SERVICE LETTER NO. 76-2
"FAA DOA EA-4 APPROVED"

DATE: February 16, 1976
SUBJECT: VENDOR SERVICE PUBLICATIONS
SERIALS AFFECTED: All Model AA-1, AA-1A, AA-1B, AA-5, AA-5A and AA-5B.
TIME OF COMPLIANCE: As indicated in each publication.

Service Bulletin No. 369B
(Supersedes Service Bulletin No. 369A)
Engineering Aspects are
FAA (DEER) Approved

Service Bulletin No. 385C
(Supersedes Service Bulletin No. 385B)
Engineering Aspects are
FAA (DEER) Approved

Figure 1. Interior View of Accessory Housing Showing Location of Cotter Pin in Oil Pump Idler Shaft

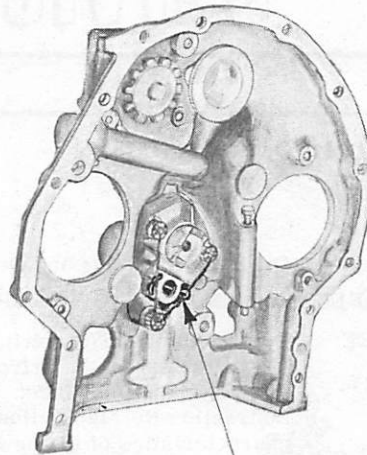
INSPECTION: Applicable remanufactured engines shipped after December 21, 1972 should be inspected to determine if this modification is required: first of all, if the engine log book indicates the engine has not been modified in accordance with Service Instruction No. 1230 or No. 1272, proceed to remove the accessory drive cover from the mounting pad at the lower right side of the accessory housing to obtain access to the area between the crankcase and the accessory housing. On some engines this accessory drive pad is not machined, in this event it will be necessary to remove either the left magneto or the *fuel pump to obtain access to the area between the crankcase and the accessory housing. Regardless of which accessory pad is used, determine if the oil pump idler gear is secured with a cotter pin at the location shown in figure 1. This can be accomplished using an inspection mirror, preferably an illuminated one. If the cotter pin is visible, it is unnecessary to perform the modification required by this bulletin.

IF IDLER SHAFT IS SECURED WITH A COTTER PIN AT THIS LOCATION MODIFICATION IS NOT REQUIRED

Figure 2. Oil Pump Drive Assembly

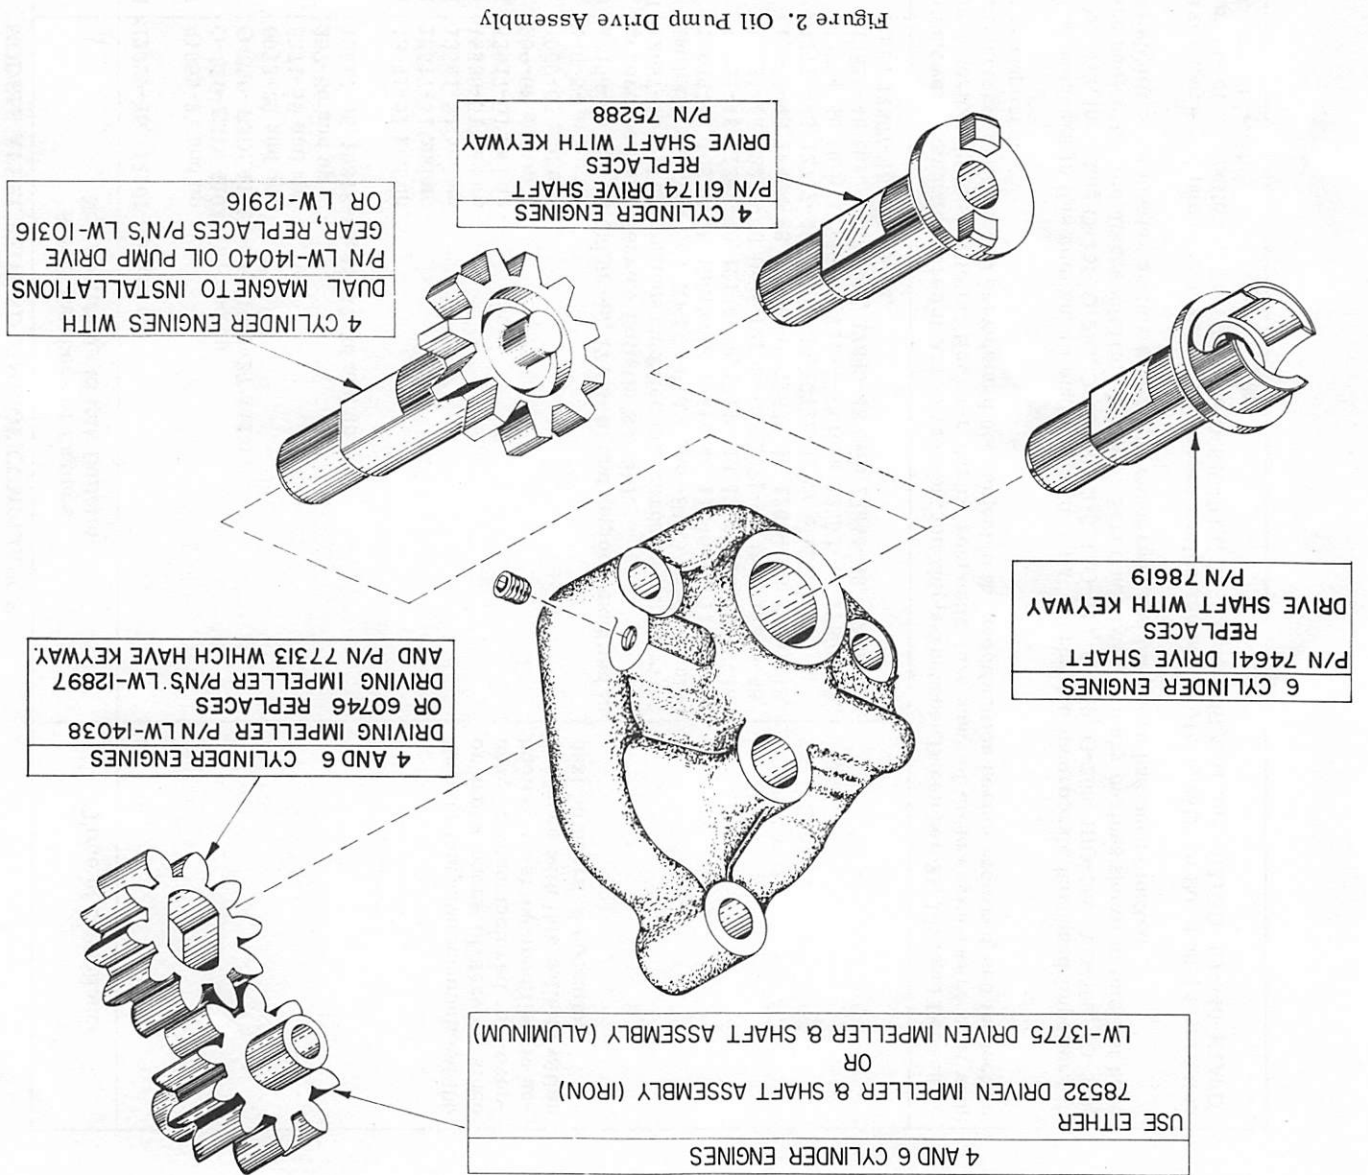
This modification consists of replacing the oil pump drive shaft and drive impeller to eliminate the Woodruff key drive which has proven to be the cause of excessive wear in the keyway of the hardened drive impeller. Therefore, it is recommended that all of the applicable engines listed in the chart, as well as any others that may have been modified in accordance with Service Instruction No. 1272, use the following procedure for parts replacement.

3. Reassemble the oil pump using the new drive shaft and drive impeller supplied with the kits shown in the following "Parts Data" section. See figure 2. Be sure all of the parts are lubricated thoroughly during assembly.

- LW-14131 Oil Pump Shaft Replacement Kit (4 cylinder engines)
consists of: (1) 61174 oil pump drive shaft, (1) LW-14038 or 60746 drive impeller

- LW-14132 Oil Pump Shaft Replacement Kit (4 cylinder, dual drive magneto engines)
consists of: (1) LW-14040 oil pump drive gear, (1) LW-14038 or 60746 drive impeller

- LW-14133 Oil Pump Shaft Replacement Kit (6 cylinder engines)
consists of: (1) 74641 oil pump drive shaft, (1) LW-14038 or 60746 drive impeller
